PROJECT
Extensions and Alterations at 2 Devon Avenue, Green Road, St Clement, JE2 6PQ

DRAWING
Ground Floor Plan: Proposed

STATUS
CONSTRUCTION

DRAWING No	REVISION
1201.20.05	M

1 Ground Floor Plan Scale: 1:50

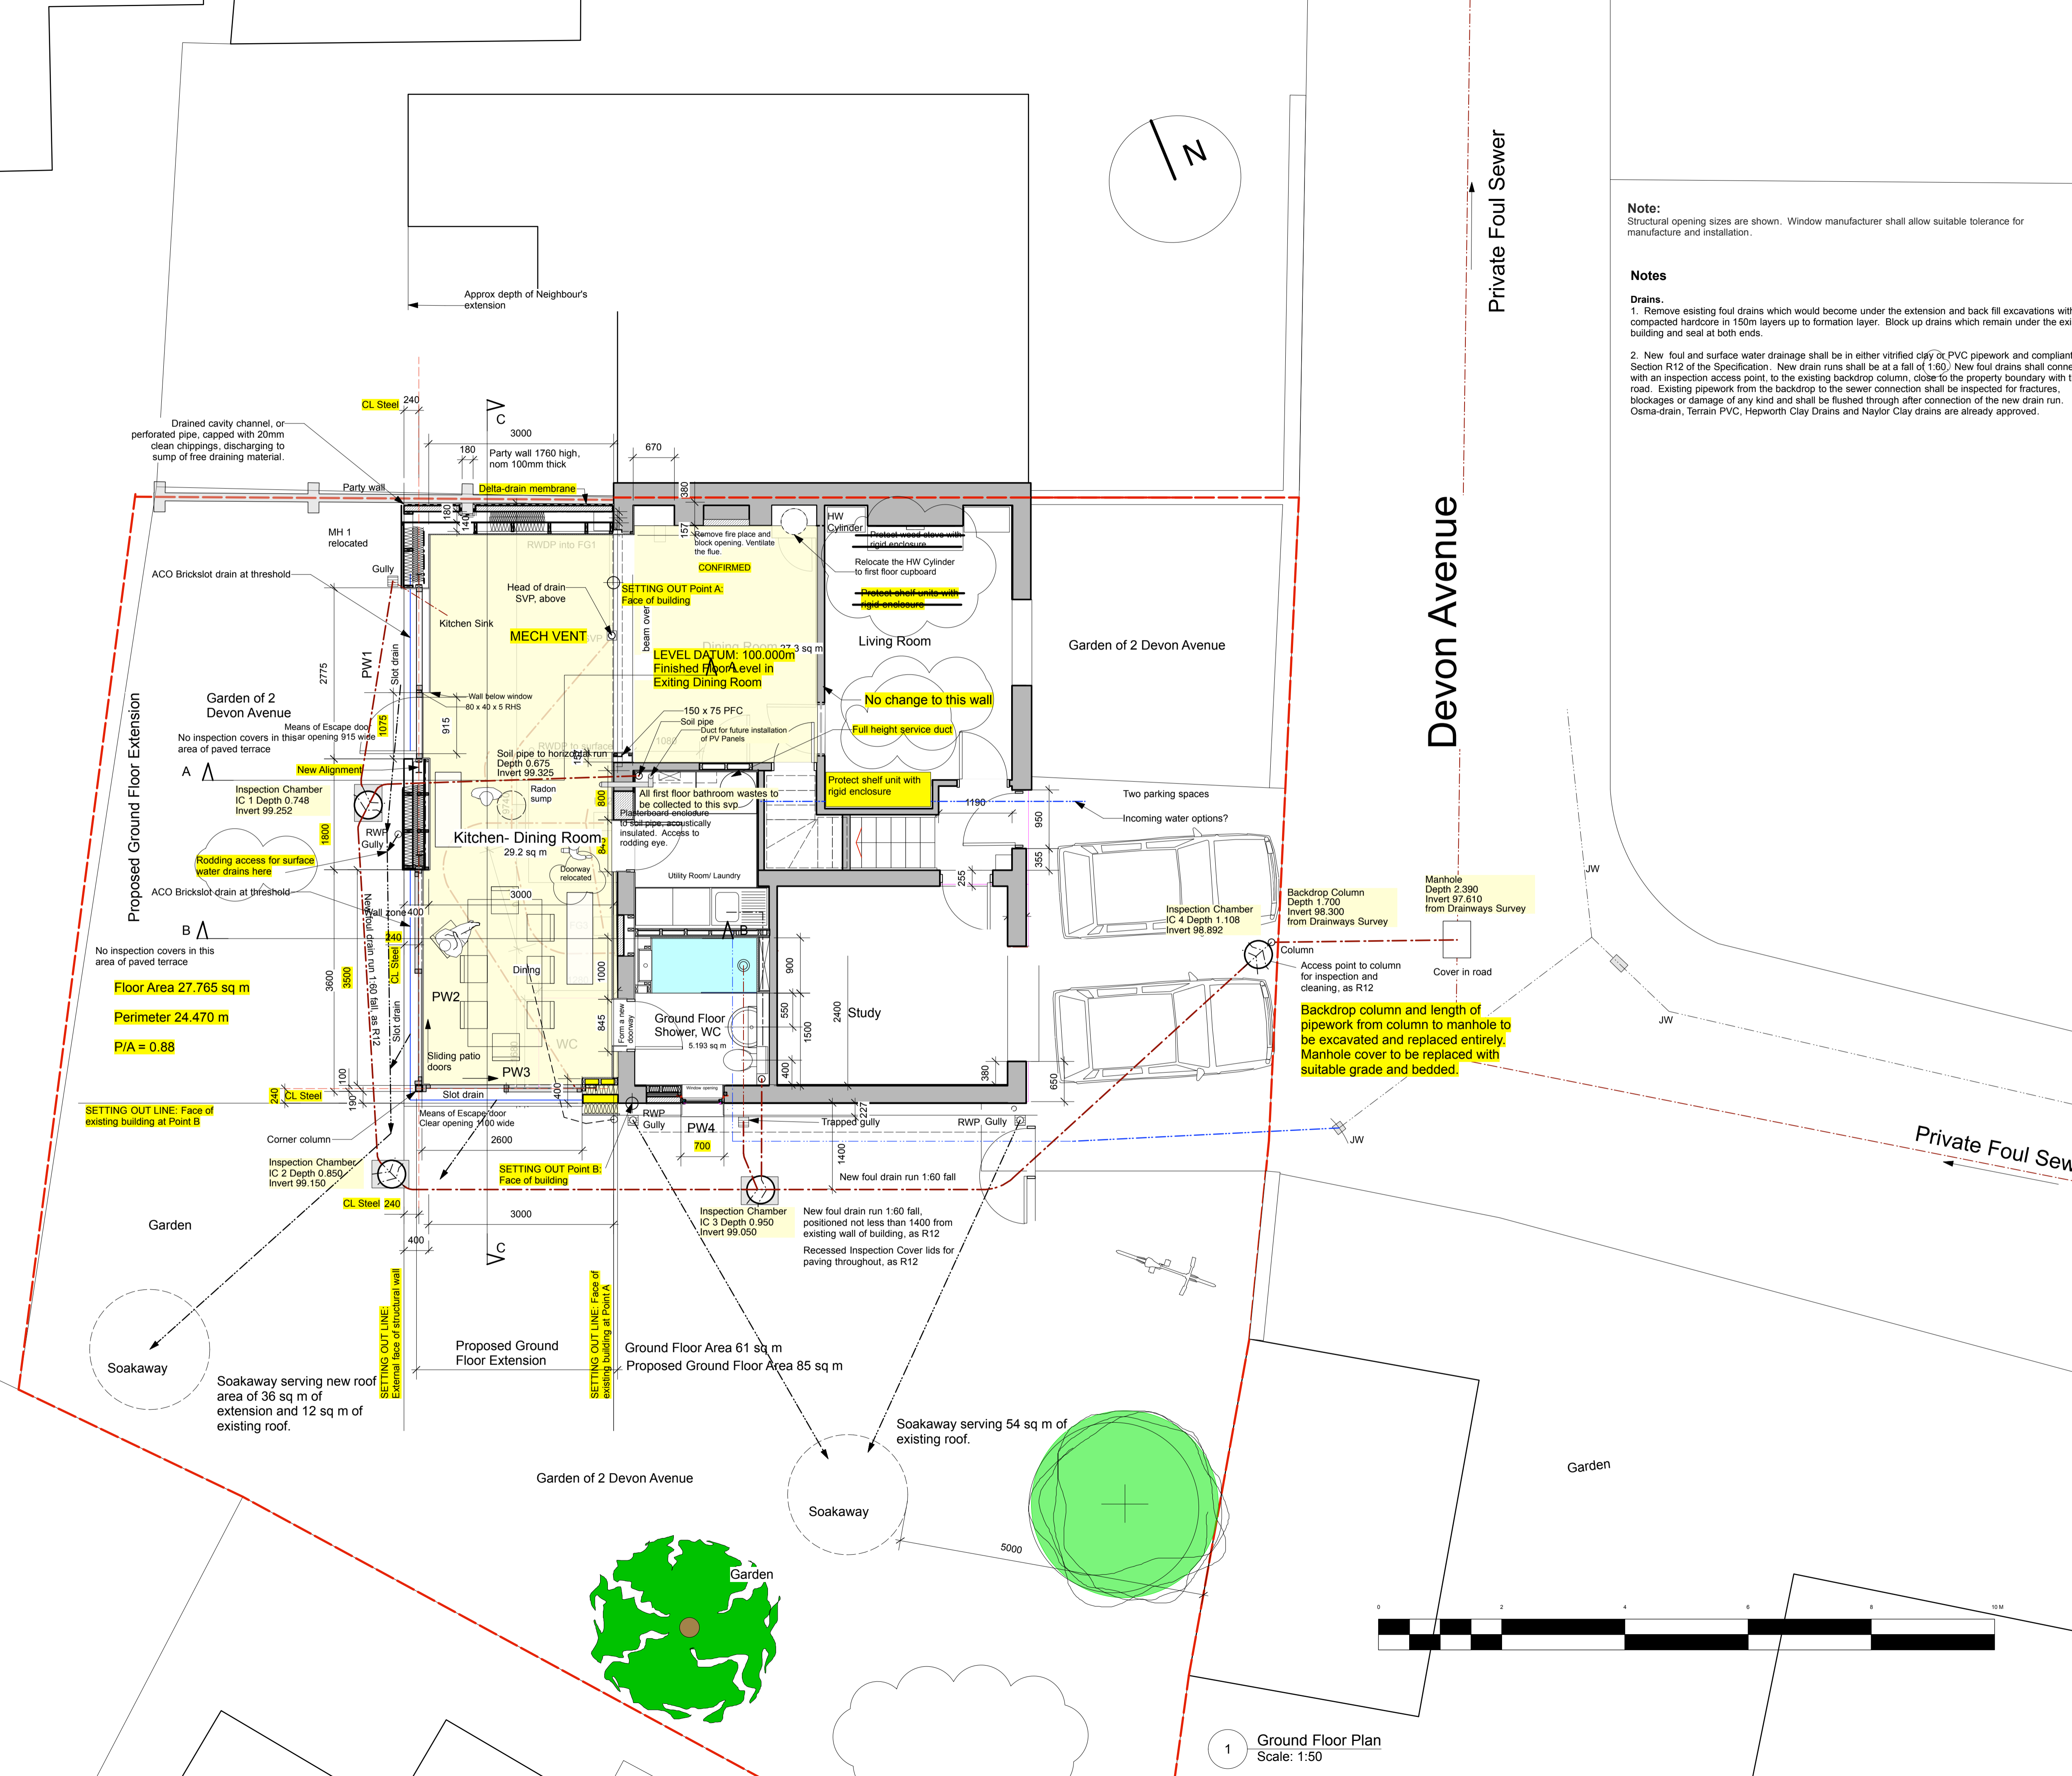
REV	DRN	CHK	AMENDMENTS	DATE
M	JSB	JSB	1. New window PW4 increased in width to 700mm.	2025.12.05
L	JSB	JSB	1. One soak-away omitted. Remaining soak-aways relocated to comply with 5m rule. Roof areas distributed between soak-aways. 2. Rodding access added on surface water route.	2025.12.05
K	JSB	JSB	1. Drainage revised, Inverts adjusted Soil pipe serving first floor relocated from Kitchen to Utility room. 2. Existing wall in Utility room to be removed.	2025.11.12
J	JSB	JSB	Engineer's PFC columns added in new opening in existing house wall. RHC added in PW1	2025.11.04
H	JSB	JSB	Backdrop column and length of drain to manhole to be replaced.	2025.10.31
G	JSB	JSB	Status changed to FOR CONSTRUCTION 1. Setting out further clarified 2. Drainage Inverts added 3. Shallow Access Chamber replaced by Inspection Chamber	2025.10.27
F	JSB	JSB	1. Setting out clarified 2. Location of capped off gas service corrected.	2025.10.17

E	JSB	JSB	1. Window and door sizes adjusted (overall area same). 2. Drains revised to reduce length of drain below the building.	2025.10.13
D	JSB	JSB	REVISED TENDER ISSUE First Floor Extension OMITTED	2025.08.22
C	JSB	JSB	TENDER ISSUE Sanitary ware added. Drains adjusted. Shower window reduced in width. Reference added to note: External Insulation Drwg 1201.21.12	2023.08.14
B	JSB	JSB	TENDER ISSUE Main services added, Drainage updated, protection of stove and shelves noted.	2023.07.25
A	JSB	JSB	Rooflight in kitchen omitted. Fenestration in kitchen changed from sliding door to window and residential door.	2023.05.15
